SBR Issues (UN R16)

KATRI

The Republic of Korea

◀ (2)
Foldable
aisle seat

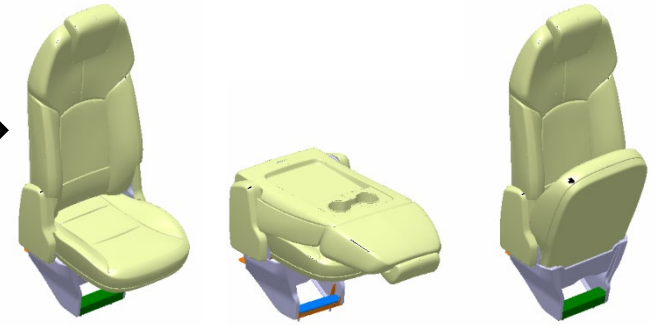
- Not compulsory on this folding seat?

- **Proposal**
 - The exception shall apply to folding seats normally folded and designed for occasional use
 - or GRSP needs to review and discuss the intention of “folding seat” in the current regulation,
 - and define clearly the “folding seat” in the regulation
 - So, CPs including technical laboratories and stakeholders understand in the same way what folding seats are for the exception
